Intersection ID: 16286	Main Street: REDDMAN_RD	Cross Street: ROCK_HOLLOW_DR	Location:	NE
ADA ID: 4E4D4BC5EDFF	Ramp Type: PerpDiag	Initial Pass/Fail: Fail	Overall Compliance: No	Severity Score: 13.75

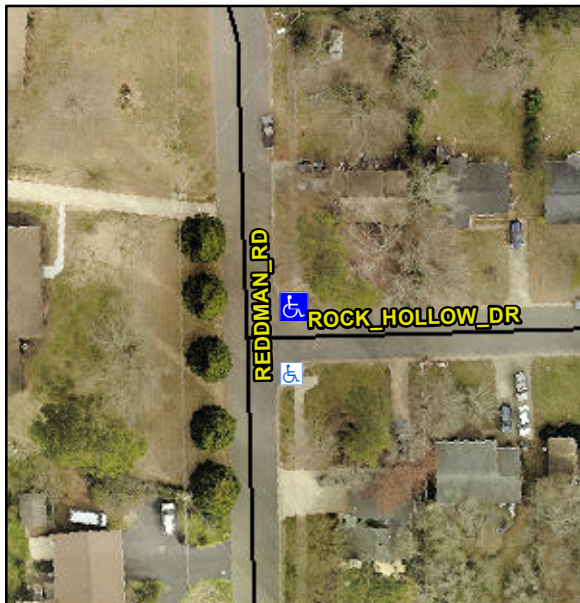
Codes/Mitigation Info/Possible Solution				Field Measurements/Component Compliance					
	Possible Solutions:			Compliance	Description	Data	Compliance	Description	Data
	Remove & Replace Curb Ramp With Two New Directional Ramps or Equivalent.			N/A	Ramp Length (in)	71.0	No	Ramp Slope (%)	8.9
				Yes	Ramp Width (in)	48.0	No	Ramp XSlope (%)	3.2
				N/A	Flare Type LT	N/A	N/A	Flare Type RT	N/A
				N/A	Flare Slope LT (%)	N/A	N/A	Flare Slope RT (%)	N/A
				N/A	Flare Traversable LT?	N/A	N/A	Flare Traversable RT?	N/A
				N/A	Landing Length (in)	N/A	N/A	DWS Provided?	N/A
				N/A	Landing Width (in)	N/A	N/A	DWS Contrast?	N/A
				N/A	Landing Slope (%)	N/A	N/A	DWS Length (in)	N/A
				N/A	Landing X Slope (%)	N/A	N/A	DWS Full Width?	N/A
<p>Surveyor Notes:</p> <p>N/A</p> <p>PROW/ADA:</p> <p>Not Found, R304.2.2, R304.5.3</p>				N/A	Landing Curb? (Y/N)	N/A	N/A	DWS Offset (in)	N/A
				N/A	Shared Landing?	N/A			
				N/A	Gutter Ponding?	N/A	N/A	Gutter Slope (%)	N/A

N/A	Gutter Lip Ht (in)	N/A	N/A	Gutter X Slope (%)	N/A
				N/A	Painted X Walk1?	No	N/A	Painted X Walk2?	No
					X Walk 1 Direction	To W		X Walk 2 Direction	To S
				N/A	X Walk 1 Width (in)	N/A	N/A	X Walk 2 Width (in)	N/A
					X Walk 1 Slope (%)	6.1		X Walk 2 Slope (%)	3.6
					X Walk 1 X Slope (%)	0.3		X Walk 2 X Slope (%)	4.2
				N/A	Ramp inside XWalk1?	N/A	N/A	Ramp inside XWalk2?	N/A
				Road Slope (%)	1.9	N/A	Clear Space?	N/A	
				Road X Slope (%)	6.3	N/A	Clear Space to XWalk (in)	N/A	
			N/A	Any Obstructions?	N/A	N/A	Storm Grate/Utility Hazard?	N/A	
				Obstruction Type			Storm Grate/Utility Type		
						N/A			N/A
							Yes	Surface Condition? (G/P)	Good
Street 1 Name				REDDMAN RD					
Stop Condition-Street 2				None					
Street 2 Name				ROCK HOLLOW DR					
Stop Condition-Street 1				StopSign					
Total Cost:				\$ 3200.00
